**SUBJECT:** NuScale Power, LLC Response to NRC Request for Additional Information No. 134 (eRAI No. 8934) on the NuScale Design Certification Application

## **Response to Request for Additional Information Docket No. 52-048**

**NRC Question No.:** 03.07.02-15

**Figure 1: Development of Average Static Pressure of 4.20 psi at Mid Height of Pool Water for SAP2000 Model to Account for 3D FSI Effects**

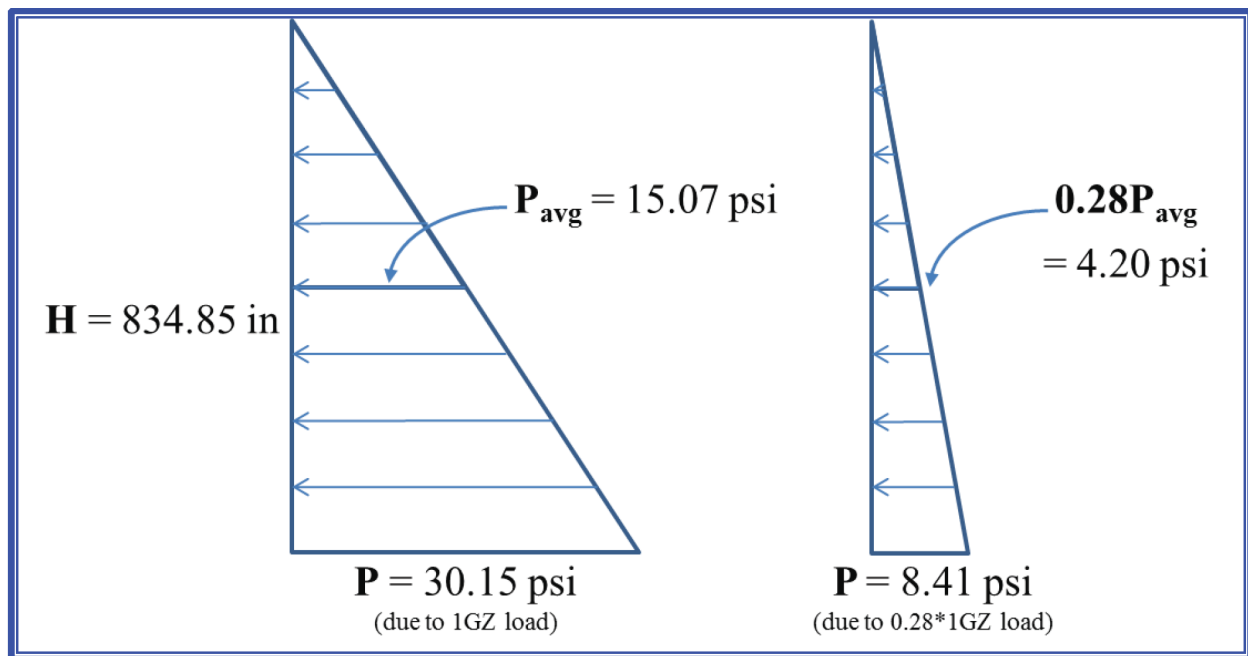
- a. On Page 3.7-30 of the FSAR, Eq. 3.7-14 represents the conversion of ANSYS FSI-based hydrodynamic pressure to SASSI2010 equivalent static pressure. In this process, ANSYS used the CSDRS-compatible Capitola time history input on a fixed-base model and SASSI2010 used the CSDRS-compatible Capitola time history input for Soil Types 7, 8, and 11, respectively. The applicant is requested to explain why FSI correction factors for the case of CSDRS-HF-compatible time history input for Soil Type 9 (hard rock) are not considered. Since the boundary conditions for an ANSYS fixed-base model and a SASSI model with Soil Type 9 (hard rock) are similar, it appears that FSI- correction factors developed for Soil Type 9 may be more representative.

- b. On Page 3.7-31 of the FSAR, the fourth paragraph, “The pressure at the bottom of the pool due to ...”, describes an approach the applicant took in taking into account the FSI effects on vertical water pressure estimation. The applicant is requested to provide a technical basis for the approach taken.

The ANSYS FSI analysis determined that an average equivalent static pressure can be applied as a load to the RXB to account for the effects of 3-D FSI that are underestimated in SSI results that use fluid mass lumping methodology. Figure 1 shows the equivalent static pool water pressure to be added is 4.20 psi, and it can be produced by applying a hydrostatic pressure due to 0.28g.

The FSI effects are accounted for by adding a pressure of 4.2 psi, obtained from ANSYS FSI analysis, to the SAP2000 model. The SAP2000 program is capable of incorporating only the lumped fluid masses and does not have the FSI analysis capability. Consequently, hydrodynamic pressures were computed separately using ANSYS FSI analysis and were added to the SAP2000 model as equivalent static load.

Total fluid pressure on wall = Hydrostatic pressure (15 psi) + Hydrodynamic pressure (4.2 psi, obtained from ANSYS FSI analysis) = 19.2 psi =  $1.28 \times 15$  psi =  $1.28 \times$  Hydrostatic pressure

Therefore, a 1.28g vertical static loading was added to the SAP2000 model to ensure the additional hydrodynamic pressure is accounted for in the design.
